**KNOXVILLE HISTORIC ZONING COMMISSION
STAFF REPORT - CERTIFICATE OF APPROPRIATENESS APPLICATION**

PROPERTY ADDRESS: 1403 Armstrong Ave 37917

FILE NO.: 1-D-18-HZ

LEVEL OF WORK: Level III. Construction of primary building - CONTINUED FROM JANUARY 18, 2018 HZC MEETING

SITE PLAN

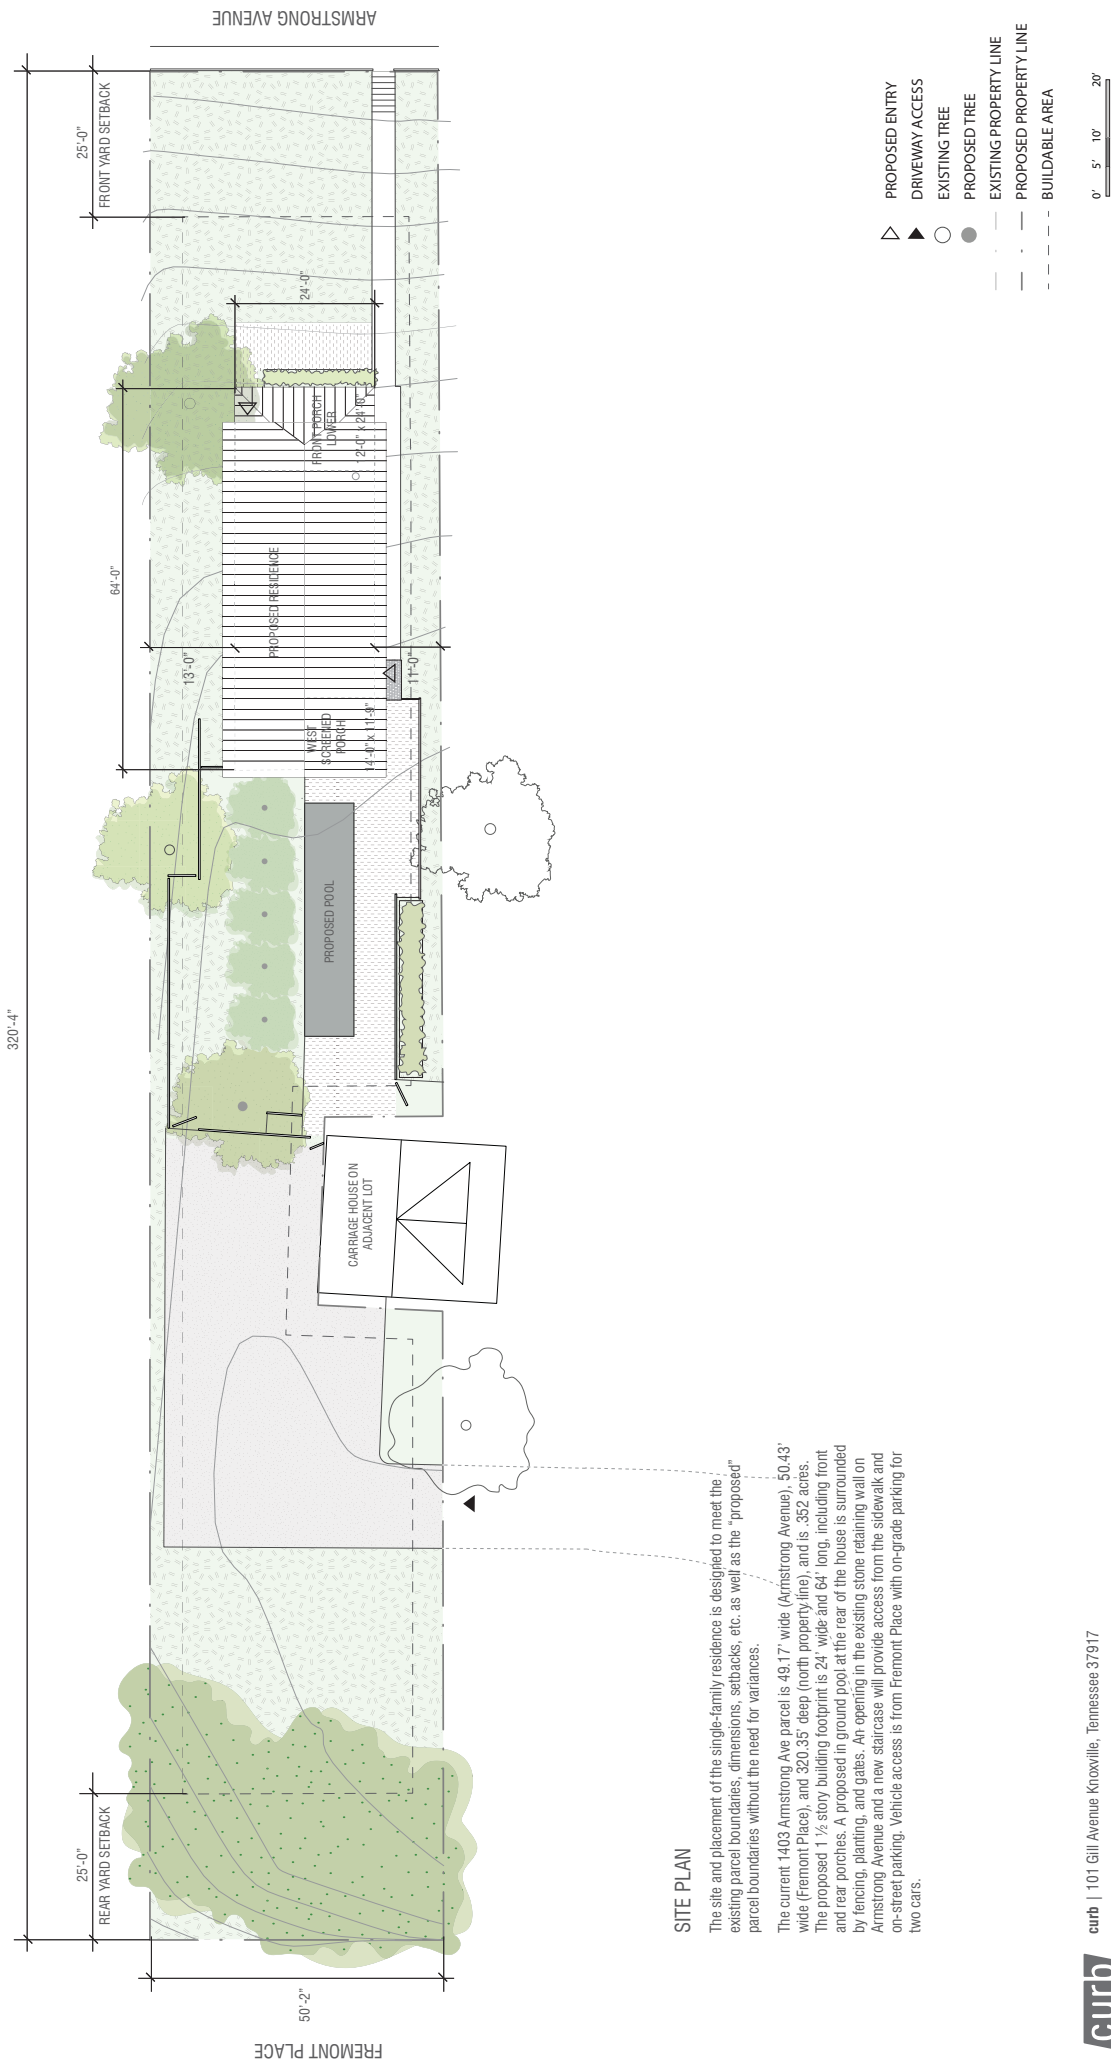
6) Based on the zoning for the street and 1403 being a lot of record, the side setbacks may be as little as 5 feet on one side and 7 feet on the other, for a total of 12 feet of setback combined. The side setbacks for the house are proposed to be 11 and 13 feet.

7) If the width of the proposed house is increased to the available 37-foot width allowed by the zoning setbacks, then the width would fall within the range (~37 to ~53 feet) of that of the houses directly across Armstrong Avenue, to the south.

8) If the width of the proposed house is increased to the available 37-foot width allowed by the zoning setbacks, then the spacing between it and the houses adjacent to it would be reduced to be less than is typical for the north side of the street (~21 to ~27 feet) on that block; however, the spacing would fall into the range of that on the south side of the street for that block (~10 to ~15 feet).

- 1) Utilize the full amount of zoning-enabled width for the house at 37 feet, and increase the height as needed to create historic proportions on the façade.
- 2) Set the house back on the lot to align with the rear-most corner of the house to the adjacent south so that the proposed structure appears as an accessory structure.
- 3) Orient the house so that it faces the street to the west of th lot, Fremont Street, since the proposed house scale is more in keeping with that of the historic houses on this street.

SOUTH ELEVATION, Side yard

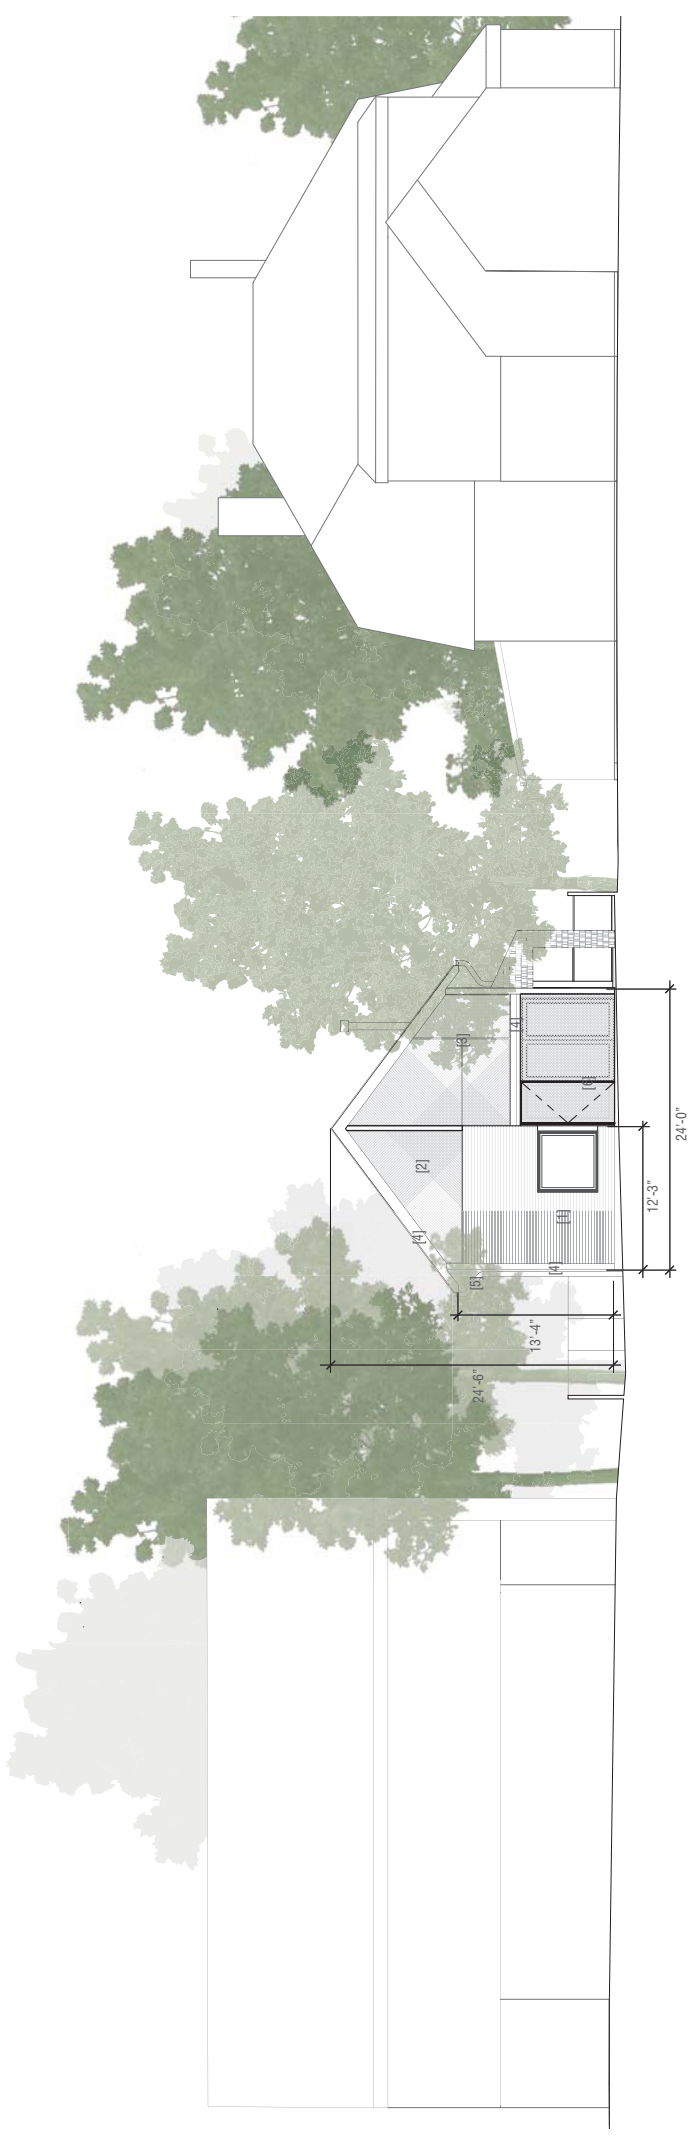
1) REVISED 2/15/18: The variety of sizes and shapes of windows on the side elevations, to include 4 different types in the same wall plane on the south side are out of character with the predominantly vertical orientation of historic windows utilized in the district. Regarding the pattern of the windows, although there are examples of free-form window patterns on the side elevations of historic houses within the district, the proposed free-form pattern on the south elevation, especially, stands out due to the lack of relief in the wall plane. The variation in pattern, size and placement of windows on the historic houses is not as visually impactful as on the proposed flat wall planes since wall planes on historic houses are delineated by recesses and projections. The placement of the lowest window on the south elevation is particularly atypical incongruent with window placement in the district. The windows on the upper facade of the north side elevation are out of character with those in the district due to their horizontality, and will be visible from the street, but not as noticeable as those on the south elevation of the house.

2) REVISED 2/15/18: The ratio of solids to voids (walls to window ratio) is appropriate on the front façade of the house. However, the side facades of the house appear more opaque than those of historic houses. Although the applicant has shown some wall planes of historic houses have a similar solid-to-void-ratio, the lack of window opening is more visually impactful on the proposed because the side elevations do not change planes and are flat, which is not typical of historic houses in the district.

4) REVISED 2/15/18: The group of 3 windows on the south side have been revised from horizontal rectangles to square windows, but are still out of character fact that they are still out of character with the block and the district as a whole because they are not vertically oriented.

- 5) Reposition and enlarge the low horizontal window on the south elevation to align with and match the size of the more central vertical window, so that there are only 3 different types and sizes of windows on the south side.

Examples of metal stove pipe through roof

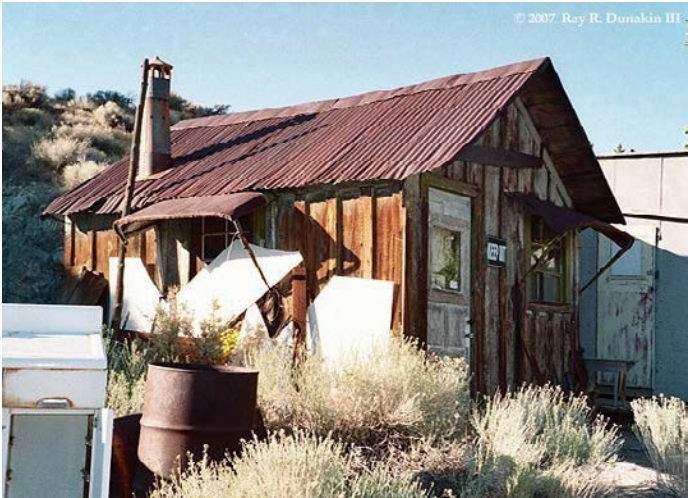
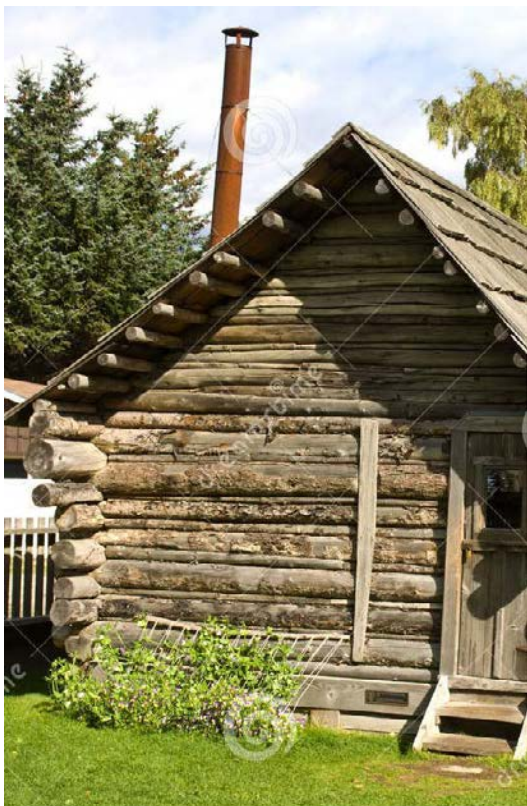
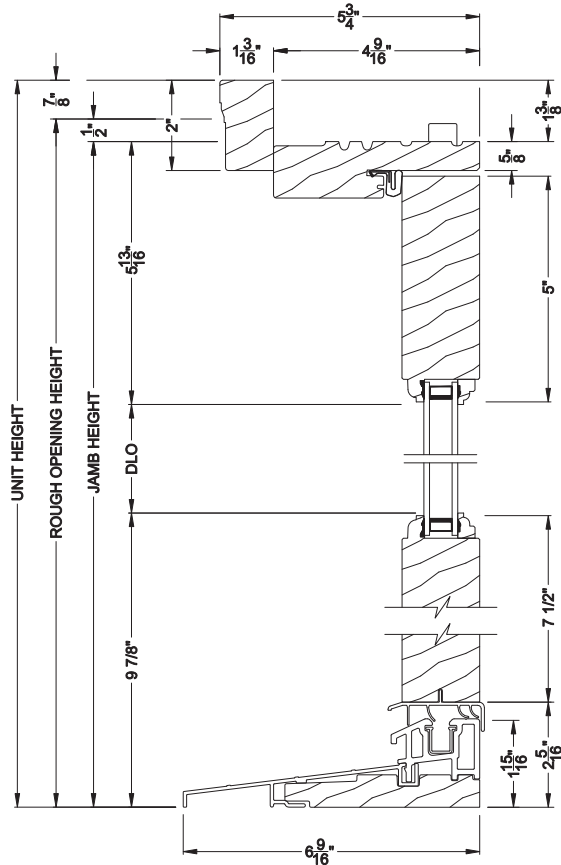
5) ADDED 2/15/18: There is no precedent in the district for the proposed metal stove pipe visible from the front and south sides of the house. The type of housing, including rustic miners cabins and shanties, in which these stove pipes were typically utilized is not present in the Old North Knoxville Historic District. The district context features architecture predominantly Victorian and Craftsman era during which stove pipes were enclosed with masonry. With the intent of setting the house apart from its historic neighbors, the metal stove pipe, as an example of functionalism gives a nod to modernist architecture. However, the gesture is such a definitive departure from the masonry chimneys of the district, that it is incongruent with the context of the district.

- 3) Eliminate the shingled wall blocking off the north side of the front porch steps.
- 4) Enclose the metal stove pipe with stuccoed or brick masonry.
